APPLICATION NO.	FILING DATE	FIRST NAMED INVENTOR	ATTORNEY DOCKET NO.	CONFIRMATION NO.
10/669,899	09/24/2003	Mitsuhiko Sato	CANO:087	2245

Office Action Summary

DETAILED ACTION

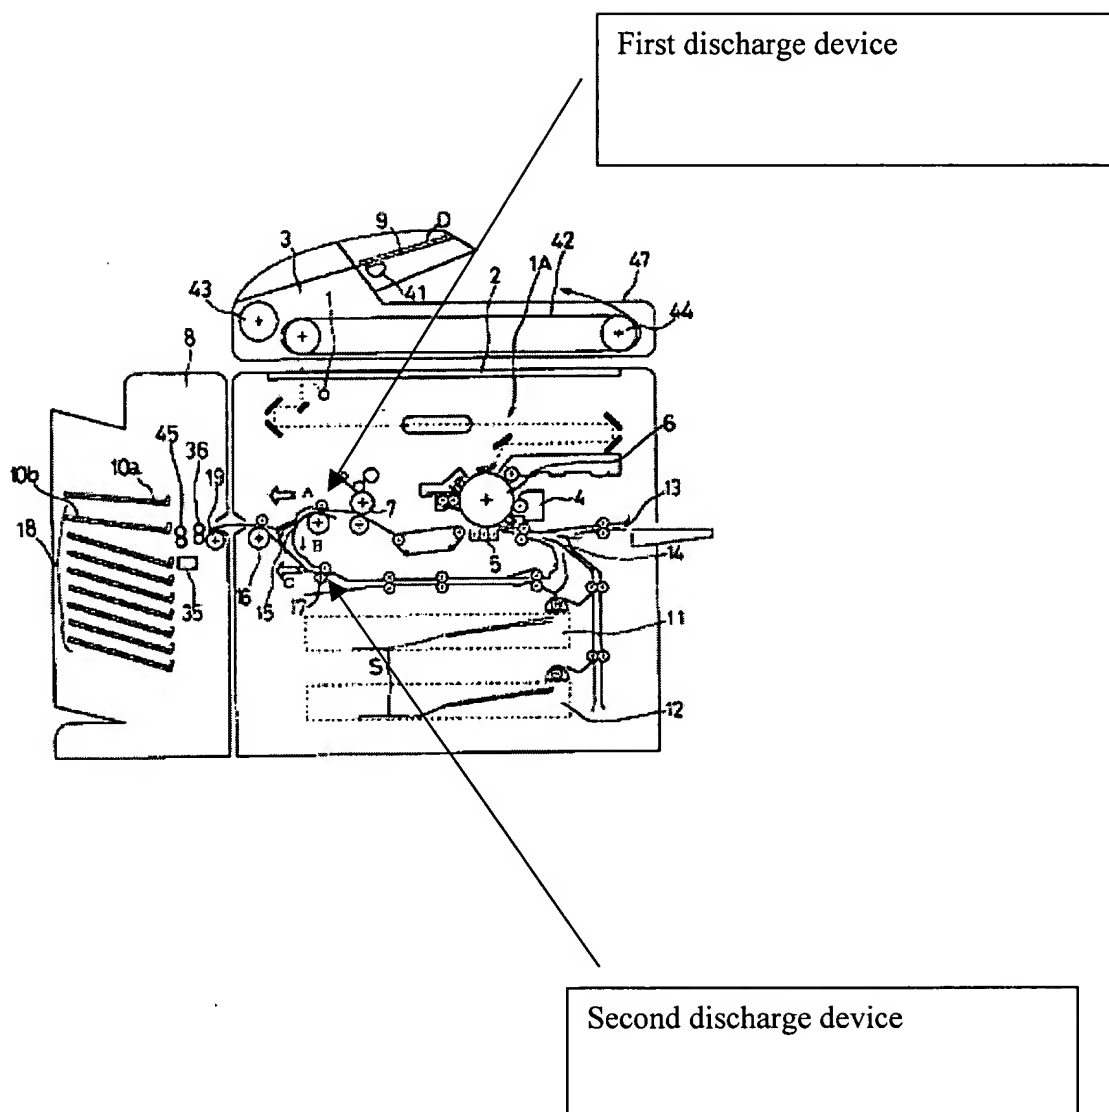
6. The applicant states that the drawings illustrate a first sheet feed device that feeds each of the tab sheets of the predetermined tab sheet bundle to an image transfer position via a first conveying path with the tab sheet being inverted because the drawings illustrate that that all sheets fed to a conveying path that inverts the sheets via the switching flapper and associated rollers described on page 31 of the specification. In response, the examiner notes that the conveying path that inverts the sheets is after the image transfer position. Therefore the path described on page 31 of the specification cannot be the claimed conveying path because it does not feed the sheets to an image transfer position. Rather, it feeds sheets from an image transfer position.
